Access Audit Site Report

Prepared By
WT Group

Martin Dies Jr. State Park
634 Park Road 48 South
Jasper, TX 75951
Accessibility Evaluation
Inspection Date: 11/10/2021
Inspectors: Tanya Scheibe

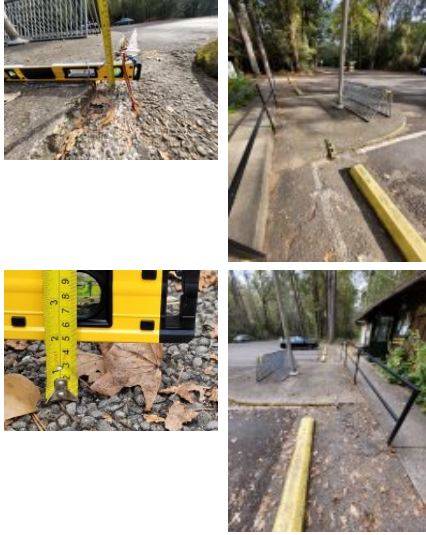
Finding Number	Area Description	Lat/Long	Finding	As Built	Recommendation	Citation	Photos	Figure
1	Headquarters: Headquarters Parking	[30.85182, -94.21043]	Element meets all standards and requirements	Lot complies with scoping - 7 standard stalls, 1 accessible.	None	2010 ADAS Section: N/A		
2	Headquarters: Headquarters Parking	[30.8465652, -94.1656881]	The cross slopes (narrow dimension) and/or running slopes (long dimension) of the access aisle exceeds 2%. The running slope and the cross slope in an accessible parking stall and the access aisle must not exceed 2%.	Slope of 5.4% in stall	Repair or correct slope of parking space and access aisle to max 2.08% in any direction	2015 ABAAS Section: 502.4 2012 TAS Section: 502.4 2010 ADAS Section: 502.4		
3	Headquarters: Headquarters Parking	[30.8465329, -94.1656961]	The accessible parking stall signage is incorrect and/or missing from each accessible parking space. Parking space identification signs shall include the International Symbol of Accessibility. Signs identifying van parking spaces shall contain the designation "van accessible." Signs shall be 60 inches minimum above the finish floor or ground surface measured to the bottom of the sign.	Lacks signage with the International Symbol of Accessibility (ISA)	Acquire and mount at appropriate heights and locations accessible parking signs where missing	2015 ABAAS Section: 502.6 2012 TAS Section: 502.6

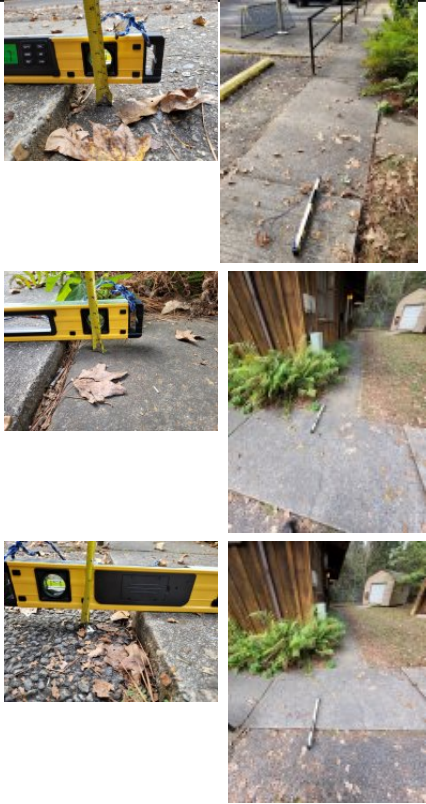
4	Headquarters: Headquarters Parking	[30.8465375, -94.1656908]	The van stall is missing a sign identifying it as a van accessible stall. Parking space identification signs shall include the International Symbol of Accessibility. Signs identifying van parking spaces shall contain the designation "van accessible."	The van stall is missing a sign identifying it as a van accessible stall	Add one van parking sign to van accessible stall and ensure stall and access aisle are 11' and 5' or 8' and 8'	2015 ABAAS Section: 502.6 2012 TAS Section: 502.6 2010 ADAS Section: 502.6

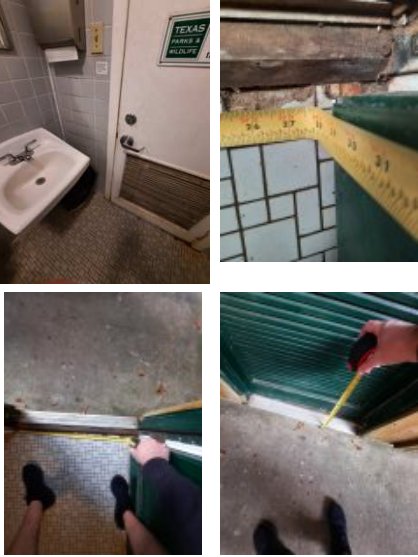
Finding Number	Area Description	Lat/Long	Finding	As Built	Recommendation	Citation	Photos	Figure
9	Headquarters: Headquarters Exterior Accessible Route	[30.8464685 , -94.165824 9]	The accessible route has running slopes greater than 5% and has not been constructed as a ramp (i.e. handrails, edge protection, etc.). Cross slopes are greater than 2% across the width of the walk. When the slope in the direction of travel of any walk exceeds 1 unit vertical in 20 units horizontal (5-percent slope), it must be constructed as a ramp. Surface cross slopes must not exceed 1 unit vertical in 48 units horizontal (2-percent slope).	Cross slope of 5.3% and running slope of 9.8% to ice machine, running slope of 12.3% near restrooms	Correct or repair cross slope along AR to max 2.08% Correct running slope along the AR to max 5%	2015 ABAAS Section: 403.3 2012 TAS Section: 403.3 2010 ADAS Section: 403.3

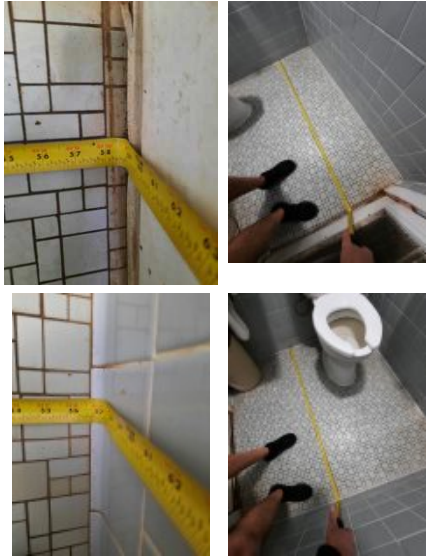
Finding Number	Area Description	Lat/Long	Finding	As Built	Recommendation	Citation	Photos	Figure
10	Headquarters: Headquarters Exterior Accessible Route	[30.84663, -94.1659]	At least one accessible route shall connect accessible buildings, accessible facilities, accessible elements, and accessible spaces that are on the same site. For areas of sport activity, an accessible route is required to connect to the boundary of each area of sport activity. The size of an area of sport activity includes only the space needed to play. Where multiple sports fields or courts are provided, an accessible route is required to each field or area of sport activity.	Lacks accessible route to bike rack and CILs of 1.5" and 2"	Provide an accessible route to each element within the site.	2010 ADAS Section: 206.2.2, 206.2		
11	Headquarters: Headquarters Exterior Accessible Route	[30.8464915 , -94.165795 4]	The walkway contains abrupt vertical edges and/or variations over a 1/4 inch. 1/4 inch is the maximum vertical rise. Changes in level between 1/4 inch and 1/2 inch must be beveled at 1:2 or less. Changes in level greater than 1/2 inch must be by way of a ramp.	Changes in level (CIL) of .75", 1", and 1.5"	Repair, bevel or ramp CIL along AR	2012 TAS Section: 303.2, 303.3 2010 ADAS Section: 303.2, 303.3

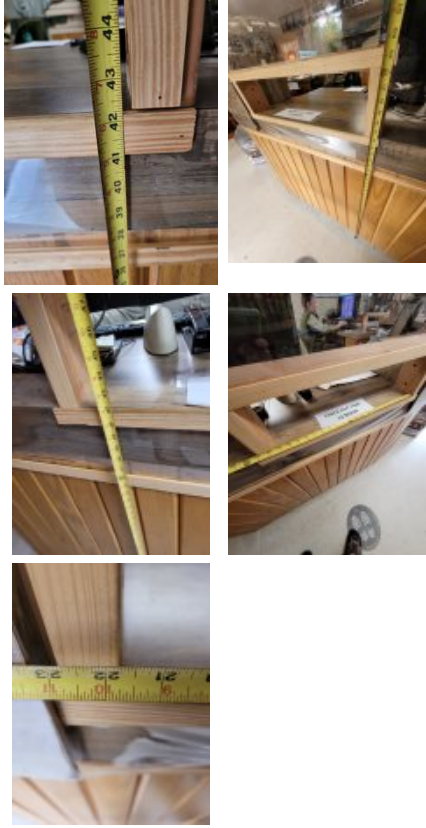
15	Headquarters: Headquarters Men's Restroom	[30.8464898 , -94.165800 9]	The restroom sign does not comply with one or more applicable requirements for the location, height, and properties of the sign.	Lacks compliant signage	Acquire and mount signage, including Braille and access symbol mounted on wall, latch side of door, 48" to baseline of lowest character and 60" to baseline of highest character	2015 ABAAS Section: F216.2, 703.1, 703.2, 703.5, 703.6 2012 TAS Section: 216.2, 703.1, 703.2, 703.5, 703.6 2010 ADAS Section: 216.2, 703.1, 703.2, 703.5, 703.6

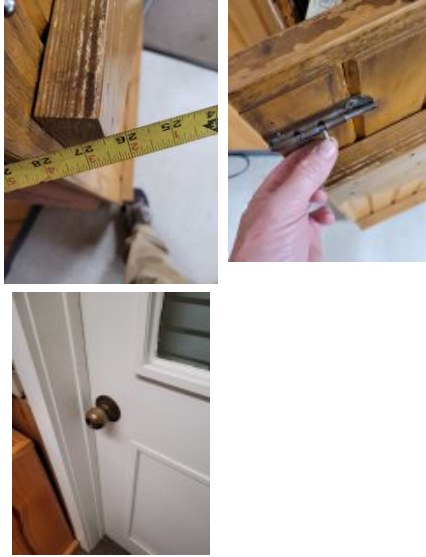
22	Headquarters: Headquarters State Parks Store	[30.8464961 , -94.165806 1]	Minimum maneuvering clearances at doors and gates shall comply with 404.2.4. Maneuvering clearances shall extend the full width of the doorway and the required latch side or hinge side clearance. Hand-activated door opening hardware, handles, pulls, latches, locks, and other operating devices on accessible doors shall have a shape that is easy to grasp with one hand and does not require tight grasping, tight pinching or twisting of the wrist to operate. Hardware shall be 34 inches minimum and 48 inches maximum above the finish floor or ground.	Storage closet - storage in pull side clearance, knob hardware	For all doors along the public circulation route, provide required maneuvering clearance on push and pull side of doors For all doors along the public circulation route, replace hardware with lever hardware or hardware operable without a tight pinch or grasp	2010 ADAS Section: 404.2.3, 404.2.7, 404.2.4, 404.2.11, 404.2.11 Exception

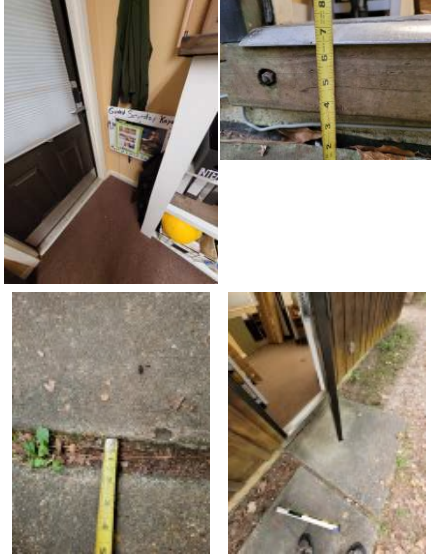
33	Headquarters: Headquarters Building	[30.8464961, -94.1658061]	The route of travel at this location does not provide a minimum width of 36 inches. The clear width shall be permitted to be reduced to 32 inches minimum for a length of 24 inches maximum provided that reduced width segments are separated by segments that are 48 inches long minimum and 36 inches wide minimum.	Break room - Lacks 36" clear width accessible route due to location of table and boxes	Relocate obstacles such as tables and chairs to create AR throughout building	2015 ABAAS Section: 403.5.1 2012 TAS Section: 403.5.1 2010 ADAS Section: 403.5.1

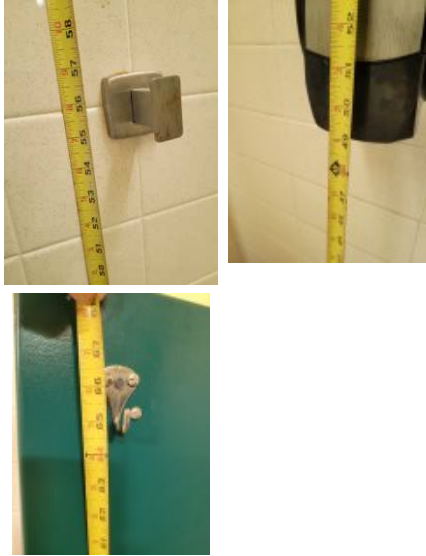
Finding Number	Area Description	Lat/Long	Finding	As Built	Recommendation	Citation	Photos	Figure
123	Hen House Ridge Unit (Sites 300-327): Hen House Ridge Unit (Sites 300-327) Dump Station	[30.84514, -94.16708]	Element meets all standards and requirements	RV dump station complies	None	2010 ADAS Section: N/A		
124	Hen House Ridge Unit (Sites 300-327): Hen House Ridge Unit (Sites 300-327) Dump Station	[30.84459, -94.16679]	There is no accessible route to the fire wood area. At least one accessible route shall connect accessible buildings, accessible facilities, accessible elements, and accessible spaces that are on the same site.	Lacks accessible route to the fire wood area	Create an accessible route with crushed stone or other outdoor material from parking or walkway to the fire wood area.	2015 ABAAS Section: F206.2.2 2012 TAS Section: 206.2.2 2010 ADAS Section: 206.2.2

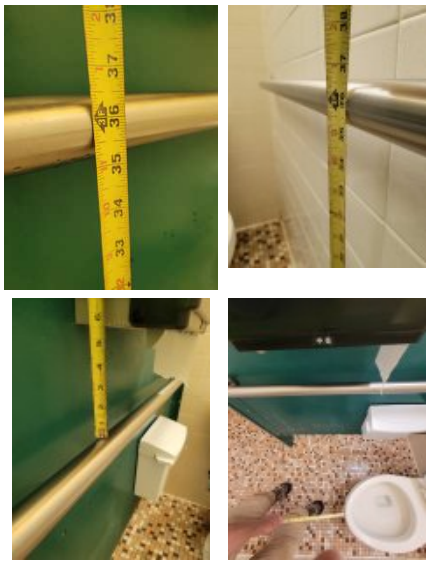
142	Hen House Ridge Unit (Sites 300-327): Hen House Ridge Unit (Sites 300-327) Men's Restroom	[30.8446181 , -94.167644 7]	The bench is not deep enough or long enough or is missing. Benches shall be provided having seats that are 42 inches long minimum and 20 inches deep minimum and 24 inches deep maximum. The bench shall provide for back support or shall be affixed to a wall. Back support shall be 42 inches (1065 mm) long minimum and shall extend from a point 2 inches (51 mm) maximum above the seat surface to a point 18 inches (455 mm) minimum above the seat surface. Back support shall be 2½ inches (64 mm) maximum from the rear edge of the seat measured horizontally. The top of the bench seat surface shall be 17 inches (430 mm) minimum and 19 inches (485 mm) maximum above the finish floor or ground. Clear floor or ground space complying with 305 shall be provided and shall be positioned at the end of the bench seat and parallel to the short axis of the bench	Bench fails required dimensions - 12" deep, 16" aff	Replace bench in dressing area with one having a seat depth of 20" to 24" deep, 42" long, affixed to the wall or having a back and mounted 17" to 19" AFF and provide required clear floor space on the short axis of the bench.	2012 TAS Section: 903.4, 903.2, 903.3, 903.5 2010 ADAS Section: 903.4, 903.2, 903.3, 903.5

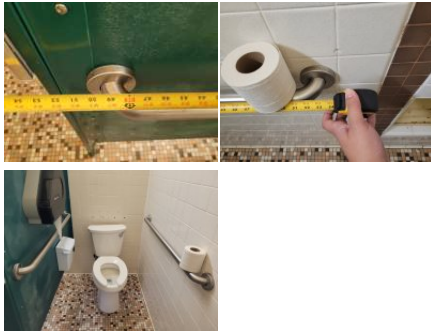
161	Hen House Ridge Unit (Sites 300-327): Hen House Ridge Unit (Sites 300-327) Women's Restroom	[30.8445882 , -94.1676233]	The shower seat does not have a compliant space between it and the wall. The folding seat must be mounted 17-19 inches above the floor, and have a maximum space of 1-1/2 inches between the edge of the seat and the side wall and 2-1/2 inches maximum to the seat wall.	The shower seat has 3" gap between it and the wall	Remount shower seat to the correct location and height in the shower	2015 ABAAS Section: 610.3.2 2012 TAS Section: 610.3.2 2010 ADAS Section: 610.3.2

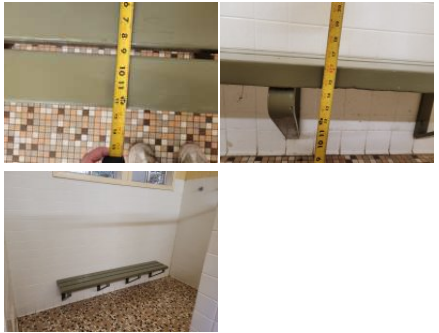
167	Hen House Ridge Unit (Shelter Sites 400-420) : Hen House Ridge Unit (Shelter Sites 400-420) Women's Restroom Bldg 4	[30.84732, -94.1709762]	The restroom sign does not comply with one or more applicable requirements for the location, height, and properties of the sign.	Lacks compliant signage, no Braille, raised lettering or symbol of access	Acquire and mount signage, including Braille and access symbol mounted on wall, latch side of door, 48" to baseline of lowest character and 60" to baseline of highest character.	2015 ABAAS Section: F216.2, 703.1, 703.2, 703.5, 703.6 2012 TAS Section: 216.2, 703.1, 703.2, 703.5, 703.6 2010 ADAS Section: 216.2, 703.1, 703.2, 703.5, 703.6

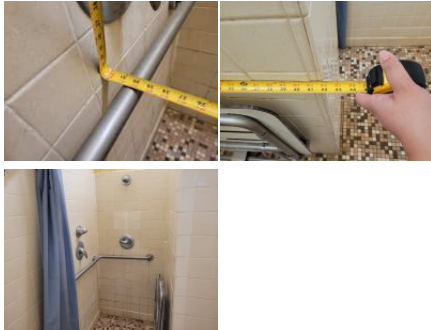
169	Hen House Ridge Unit (Shelter Sites 400-420) : Hen House Ridge Unit (Shelter Sites 400-420) Women's Restroom Bldg 4	[30.8473073 , -94.1709909]	There are not enough accessible toilet compartments. The room contains several toilet compartments. A minimum of 1 must be wheelchair accessible .	Lacks wheelchair accessible stall, ambulatory only	Create a wheelchair accessible stall with grab bars and fixtures mounted in correct locations and at correct heights.	2015 ABAAS Section: F213.3.1 2012 TAS Section: 213.3.1 2010 ADAS Section: 213.3.1

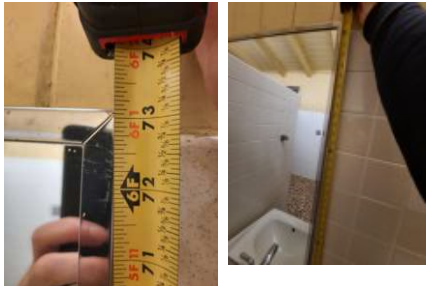
173	Hen House Ridge Unit (Shelter Sites 400-420) : Hen House Ridge Unit (Shelter Sites 400-420) Women's Restroom Bldg 4	[30.8473073 , -94.170985 6]	The accessible route contains running slopes greater than 5 percent and cross slopes greater than 2 percent across the width of the walk and has not been constructed as a ramp (i.e. handrails, wheel guides, etc.). When the slope in the direction of travel of any walk exceeds 1 unit vertical in 20 units horizontal (5-percent slope), it must be constructed as ramp. Surface cross slopes must not exceed one unit vertical in 48 units. Horizontal (2-percent slope).	Slope of 4.5% near floor drain	Correct or repair slope to max 2.08%.	2015 ABAAS Section: 403.3 2012 TAS Section: 403.3 2010 ADAS Section: 403.3		
174	Hen House Ridge Unit (Shelter Sites 400-420) : Hen House Ridge Unit (Shelter Sites 400-420) Exterior Accessible Route	[30.8473338 , -94.171178 7]	At least one accessible route shall connect accessible buildings, accessible facilities, accessible elements, and accessible spaces that are on the same site. For areas of sport activity, an accessible route is required to connect to the boundary of each area of sport activity. The size of an area of sport activity includes only the space needed to play. Where multiple sports fields or courts are provided, an accessible route is required to each field or area of sport activity.	Lacks route to play area (6 swings), sand surface	Provide an accessible route to play elements and replace surface with an accessible surface.	2010 ADAS Section: 206.2.2, 206.2

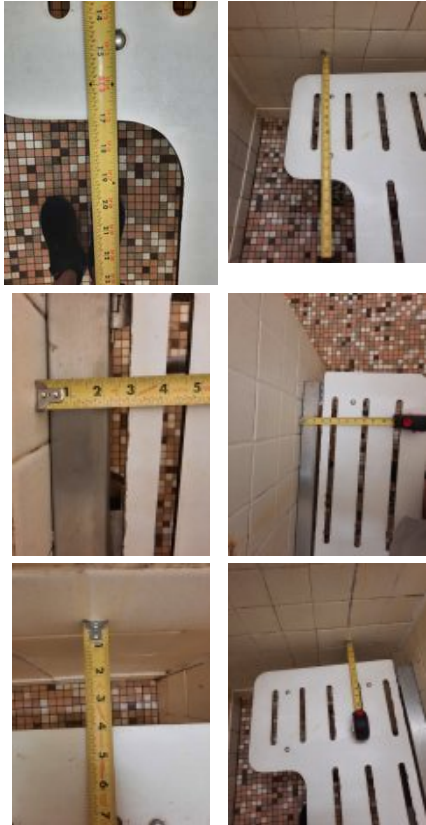
Finding Number	Area Description	Lat/Long	Finding	As Built	Recommendation	Citation	Photos	Figure
278	Hen House Ridge Unit Day Use Area: Hen House Ridge Unit Day Use Area Women's Restroom (near site 128)	[30.8432221 , -94.1733137]	The stall door fails to comply with all of the door requirements. The stall door must be a minimum of 32" wide and have compliant hardware on both sides. The stall door must be self-closing.	Lacks self-closing door	Adjust stall door to be self-closing	2015 ABAAS Section: 404.2.3, 404.2.7, 604.8.2.2 2012 TAS Section: 404.2.3, 404.2.7, 604.8.2.2 2010 ADAS Section: 404.2.3, 404.2.7, 604.8.2.2		
279	Hen House Ridge Unit Day Use Area: Hen House Ridge Unit Day Use Area Women's Restroom (near site 128)	[30.8432382 , -94.1733084]	The side grab bars are not in the correct location. Grab bars on the side wall must be installed so that the end closest to the rear wall is maximum 12" from the rear wall. The end furthest from the rear wall must be mounted minimum 54" from the rear wall.	Side grab bars end at 52" from rear wall	Remount side grab bar to max 12" from the rear wall at the close end and min 54" on the far end, and 33" to 36" aff in new wheelchair stall.	2015 ABAAS Section: 604.5.1 2012 TAS Section: 604.5.1 2010 ADAS Section: 604.5.1

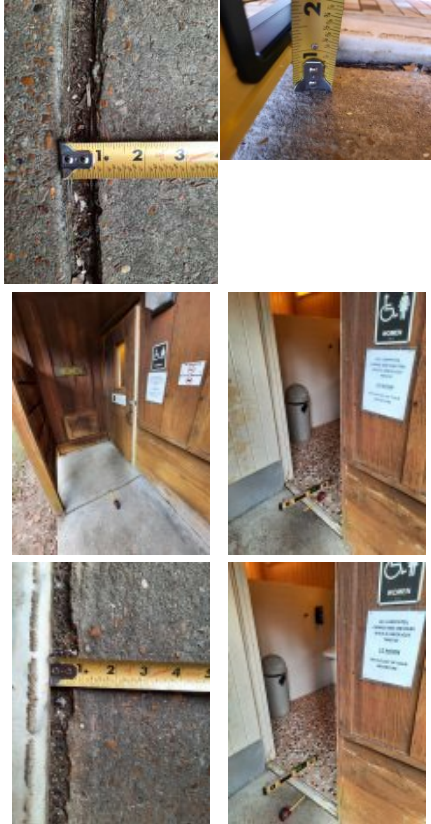
304	Walnut Ridge Unit (Sites 549-574): Walnut Ridge Unit (Sites 549-574) Men's Restroom Bldg 5B	[30.8600546 , -94.175915 5]	The stall door fails to comply with all of the door requirements. The stall door must be a minimum of 32" wide and have compliant hardware on both sides. The stall door must be self-closing.	Lacks self-closing door	Adjust stall door to be self-closing.	2015 ABAAS Section: 404.2.3, 404.2.7, 604.8.2.2 2012 TAS Section: 404.2.3, 404.2.7, 604.8.2.2 2010 ADAS Section: 404.2.3, 404.2.7, 604.8.2.2

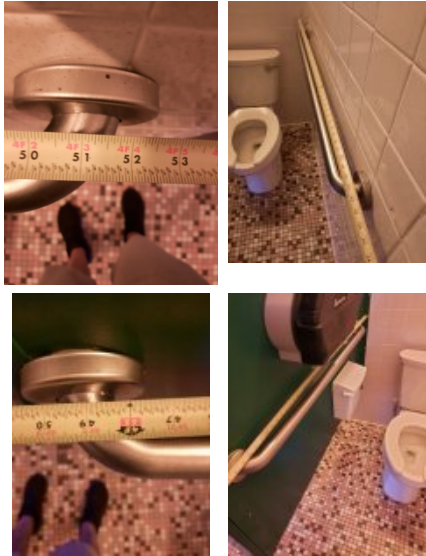
311	Walnut Ridge Unit (Sites 549-574): Walnut Ridge Unit (Sites 549-574) Men's Shower Bldg 5B	[30.8600742 , -94.175912 8]	The bench is not deep enough or long enough or is missing. Benches shall be provided having seats that are 42 inches long minimum and 20 inches deep minimum and 24 inches deep maximum. The bench shall provide for back support or shall be affixed to a wall. Back support shall be 42 inches (1065 mm) long minimum and shall extend from a point 2 inches (51 mm) maximum above the seat surface to a point 18 inches (455 mm) minimum above the seat surface. Back support shall be 2½ inches (64 mm) maximum from the rear edge of the seat measured horizontally. The top of the bench seat surface shall be 17 inches (430 mm) minimum and 19 inches (485 mm) maximum above the finish floor or ground. Clear floor or ground space complying with 305 shall be provided and shall be positioned at the end of the bench seat and parallel to the short axis of the bench	Bench lacks required dimensions - 12" deep, 16.25" aff	Replace bench in dressing area with one having a seat depth of 20" to 24" deep, 42" long, affixed to the wall or having a back and mounted 17" to 19" AFF and provide required clear floor space on the short axis of the bench.	2012 TAS Section: 903.4, 903.2, 903.3, 903.5 2010 ADAS Section: 903.4, 903.2, 903.3, 903.5

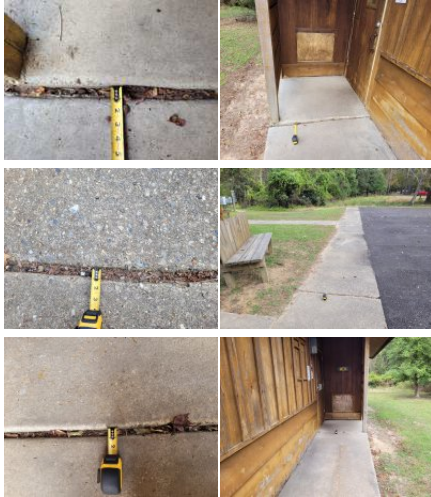
Finding Number	Area Description	Lat/Long	Finding	As Built	Recommendation	Citation	Photos	Figure
323	Walnut Ridge Unit (Sites 549-574): Walnut Ridge Unit (Sites 549-574) Women's Restroom Bldg 5B	[30.8600731 , -94.175915 5]	The grab bar height and/or spacing fails. Grab bars must be mounted between 33" and 36" to the top of the gripping surface. There must be 1.5" of clearance between the grab bar and the wall. There must be a minimum of 1.5" of clearance below and minimum 12" above the grab bar to any dispenser or other obstruction.	Gripping surface of grab bars are 36.5" aff, and TP 4.5" above bar and too close to toilet	Remount grab bars in accessible stall to 33" to 36" aff Remount toilet paper dispenser max 7" to 9" from front of toilet, 15" to 48" aff and min 12" above or 1.5" below grab bar	2015 ABAAS Section: 609.3, 609.4 2012 TAS Section: 609.4, 609.3 2010 ADAS Section: 609.3, 609.4

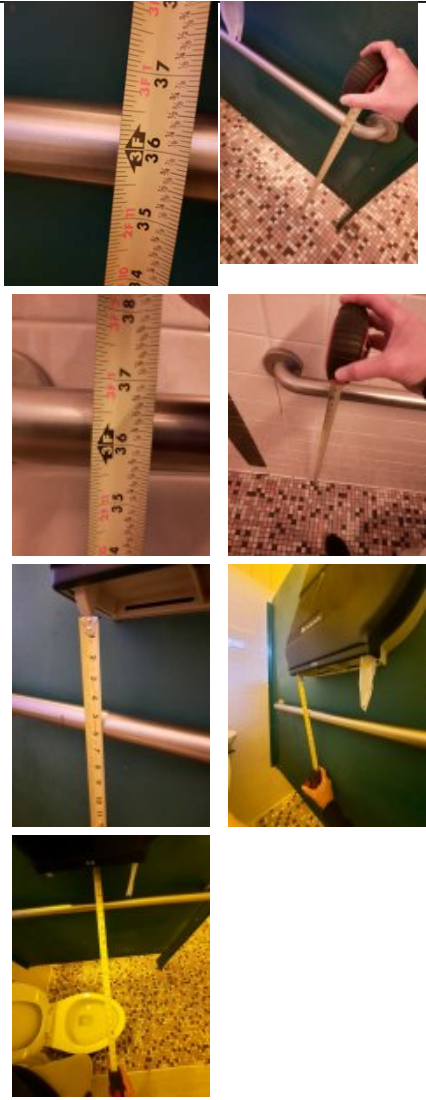
332	Walnut Ridge Unit (Sites 500-548): Walnut Ridge Unit (Sites 500-548) Restroom Parking and Exterior Accessible Route Bldg 5A	[30.8586896 , -94.179307 1]	The walkway contains abrupt vertical edges and/or variations over a 1/4 inch. 1/4 inch is the maximum vertical rise. Changes in level between 1/4 inch and 1/2 inch must be beveled at 1:2 or less. Changes in level greater than 1/2 inch must be by way of a ramp.	Change in level (CIL) of 1.25" at women's restroom	Repair, bevel or ramp CIL along route	2012 TAS Section: 303.2, 303.3 2010 ADAS Section: 303.2, 303.3		
333	Walnut Ridge Unit (Sites 500-548): Walnut Ridge Unit (Sites 500-548) Restroom Parking and Exterior Accessible Route Bldg 5A	[30.8586447 , -94.179304 9]	The accessible route of travel on the accessible route contains cross slopes greater than 2%. Cross slopes shall not exceed one unit vertical in 48 units horizontal (2-percent slope).	Cross slope of 2.9% cross to women's restroom	Correct or repair cross slope along route to max 2.08%.	2015 ABAAS Section: 403.3 2012 TAS Section: 403.3 2010 ADAS Section: 403.3

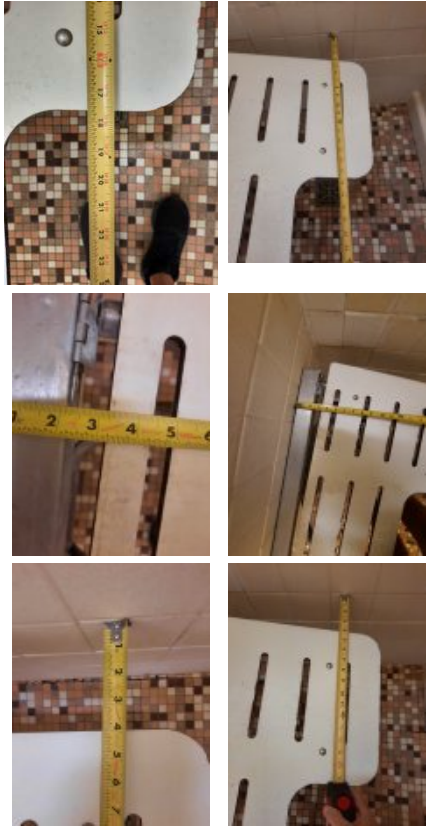
343	Walnut Ridge Unit (Sites 500-548): Walnut Ridge Unit (Sites 500-548) Men's Restroom Bldg 5A	[30.8587123, -94.179287]	There are not enough accessible toilet compartments. The room contains 2 toilet compartments. A minimum of 1 must be wheelchair accessible .	Lacks wheelchair accessible stall, ambulatory only	Create a wheelchair accessible stall with grab bars and fixtures mounted in correct locations and at correct heights	2015 ABAAS Section: F213.3.1 2012 TAS Section: 213.3.1 2010 ADAS Section: 213.3.1

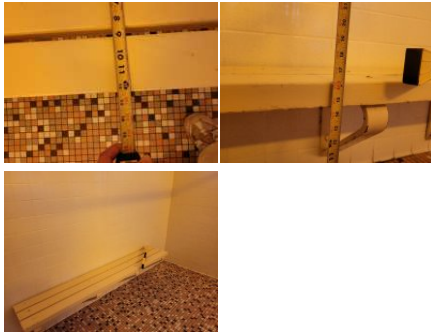
350	Walnut Ridge Unit (Sites 500-548): Walnut Ridge Unit (Sites 500-548) Men's Shower Bldg 5A	[30.8587215, -94.179279]	Transfer type shower compartments shall be 36 inches (915 mm) by 36 inches (915 mm) clear inside dimensions measured at the center points of opposing sides and shall have a 36 inch (915 mm) wide minimum entry on the face of the shower compartment. Clearance of 36 inches (915 mm) wide minimum by 48 inches (1220 mm) long minimum measured from the control wall shall be provided.	Transfer shower 32.75" wide	Enlarge transfer shower to compliant 36" by 36" clear inside dimension.	2015 ABAAS Section: 608.2.1 2012 TAS Section: 608.2.1 2010 ADAS Section: 608.2.1
